Beaver Valley Power Station, Unit No. 2  
Docket No. 50-412, License No. NPF-73

Response to Request for Additional Information Related to Beaver Valley Power Station  
Unit No. 2 Spent Fuel Pool Rerack License Amendment Request (TAC No. ME1079)

Response to March 19, 2010 NRC Request for Additional Information Related to Beaver Valley Power Station Unit No. 2 Spent Fuel Pool Rerack License Amendment Request

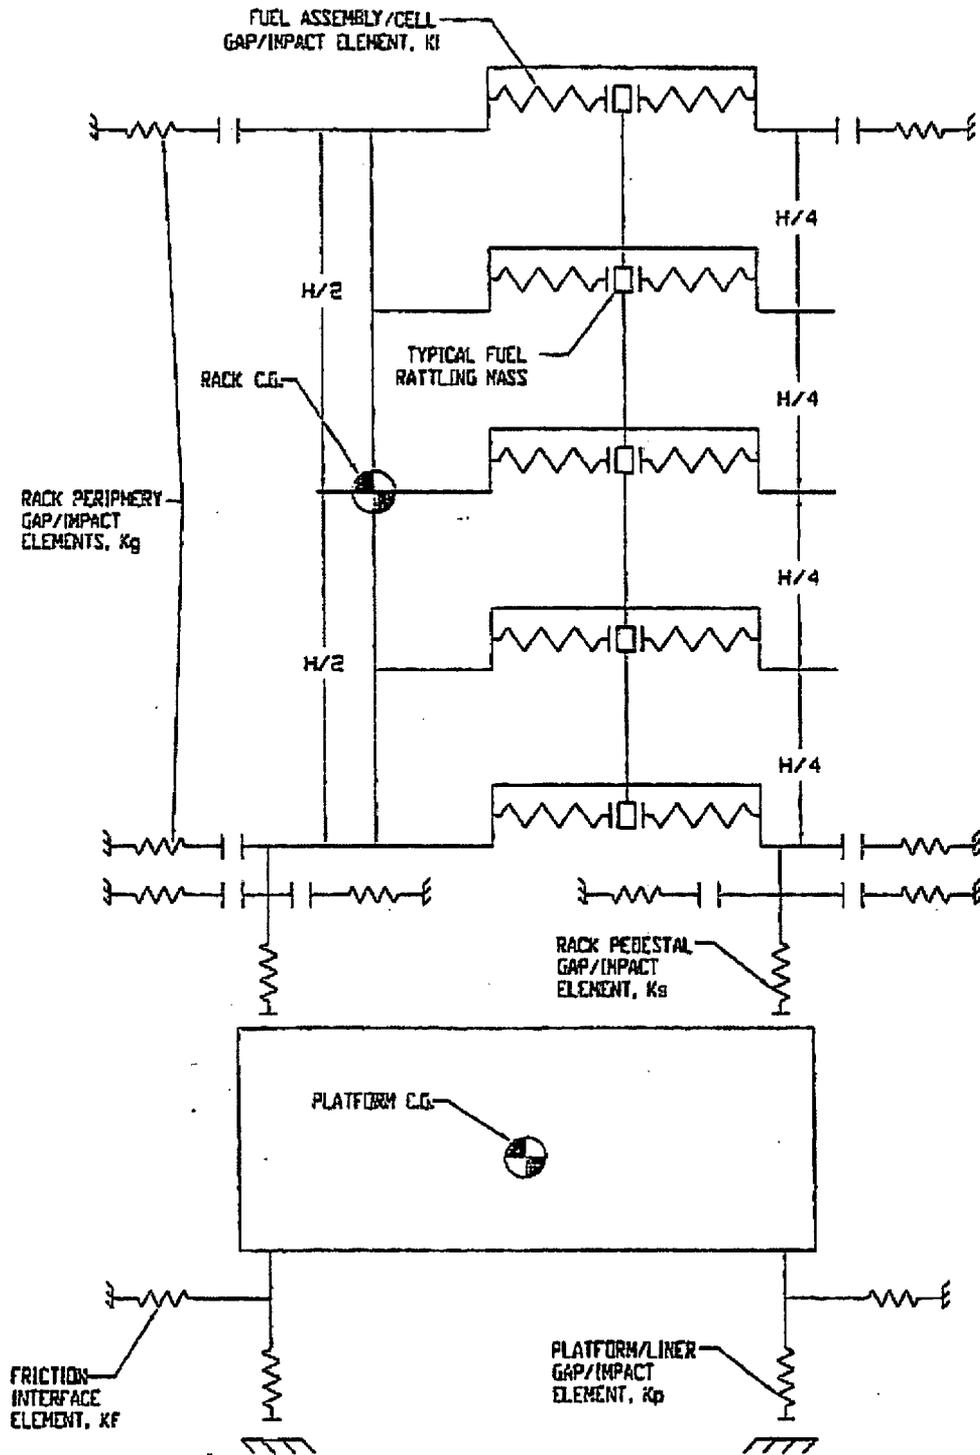
**13. Section 5.7 of Enclosure C in Reference 1, "Cask Pit Rack Platform Analysis," stated that a single rack analysis is performed to evaluate the seismic loads induced on the cask pit rack platform. Due to the dynamic characteristics of the cask pit platform, there may be possible amplification of seismic input motion. Provide justification relative to the decoupling of the rack and the cask pit platform in the seismic analysis.**

To assess the seismic amplification due to the dynamic characteristics of the cask pit platform, the seismic analysis documented in Reference 3 has been re-performed using a coupled model, which includes both the rack and the cask pit platform. The figure below shows a schematic of the coupled model, which is implemented using the computer program DYNARACK.

The cask pit platform is modeled as a six degree of freedom rectangular body of appropriate size and mass, which is capable of twisting, rocking, and sliding relative to the cask pit floor. The spent fuel rack sits atop the platform in a freestanding manner.

A combination of non-linear gap elements and friction elements are used to define the contact interfaces between the rack support pedestals and the platform, and the platform and the cask pit floor.

The results obtained from the decoupled rack model and the coupled rack/platform model are summarized in the table below.

Based on the above table, the seismic response of the cask pit rack is slightly amplified when the platform is included in the model. The displacements shown above are insignificant, and will neither cause the rack to slide off the platform nor to tip over. Therefore, the stress analysis of the cask pit rack platform has been re-performed (Reference 3) using the maximum pedestal forces from the coupled rack/platform model. The calculated stresses in the platform continue to meet the Level D stress limits per American Society of Mechanical Engineers (ASME) Code, Section III, Subsection NF (Reference 4). The minimum calculated safety factor is 1.084, where

Figure RAI- 20-1 LS-DYNA Model of 12 x 12 Sizewell Rack

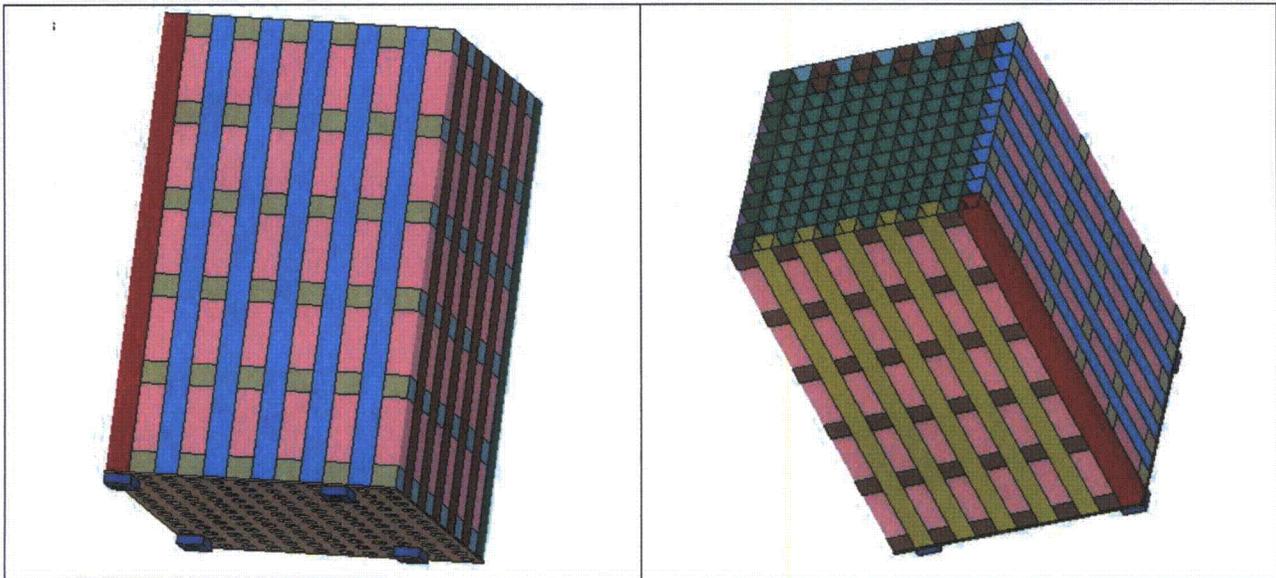
- 20. As discussed in Section 5.4.2.1 of Reference 1, a simplified 3-D lumped mass dynamic model of the single rack structure is used in the whole pool multi-rack analysis. Response 6 in Reference 2 indicated that the use of a single-beam and two-node to model a BVPS-2 rack module is justified because the lowest natural frequency of the rack cellular structure is above 33 Hertz. Please provide more information relative to benchmarking of this model against a detailed finite element model to demonstrate the adequacy of the simplified mass model to predict the anticipated time history seismic responses.**

In 2008, Holtec developed a detailed finite element model of a 12 by 12 pressurized water reactor (PWR) spent fuel rack (Reference 6) for Sizewell nuclear plant. This nuclear power plant is located in England and operated by British Energy. The model, which is shown below in the Figure RAI-20-1, was built using LS-DYNA.

As shown in the figure above, all load bearing components of the spent fuel rack, including the support pedestals, the base plate, the cell walls, and the weld connections, were modeled explicitly using a combination of thick shell, shell, and solid elements. In addition to the rack structural components, the stored fuel assemblies were individually modeled in LS-DYNA as separate bodies and positioned within every storage cell location. Appropriate contact interfaces were defined between the cell walls, the base plate, and the fuel assemblies to allow each fuel assembly to rattle freely inside its storage cell under the applied loading. The entire model included nearly 200,000 elements.

A seismic analysis of the 12 by 12 Sizewell rack was performed by simultaneously applying three orthogonal acceleration time histories to the LS-DYNA model. For this analysis, the spent fuel rack was assumed to be freestanding in air (rather than in water) since it is difficult to model fluid-structure interactions in LS-DYNA directly. To offset this conservative assumption, an attenuation factor was applied to the horizontal input accelerations to account for the effect of the water.

In parallel with the LS-DYNA work, a separate analysis was performed using DYNARACK for the same 12 by 12 Sizewell rack in air, under the same earthquake and fuel assembly loading conditions. Additionally, the Sizewell rack was modeled in DYNARACK using the standard modeling approach (that is, two-node, single beam rack model). Table RAI-20-1 summarizes the results predicted by both models.

As expected, the DYNARACK model predicts larger rack displacements than LS-DYNA mainly because of the conservative manner in which rattling fuel assemblies are modeled in DYNARACK. The DYNARACK model assumes that all fuel assemblies rattle in-phase by virtue of the fact that the total mass of the stored fuel assemblies is lumped into a single fuel column. By contrast, the fuel assemblies are individually modeled in LS-DYNA, and therefore they are capable of rattling out-of-phase (as would actually occur in a seismic event). Out-of-phase rattling reduces the net impact between the stored fuel and the spent fuel rack, which in turn leads to smaller rack displacements. Thus, the simplified mass model utilized in DYNARACK provides a conservative prediction of the maximum rack displacements and fuel-to-cell impact load.
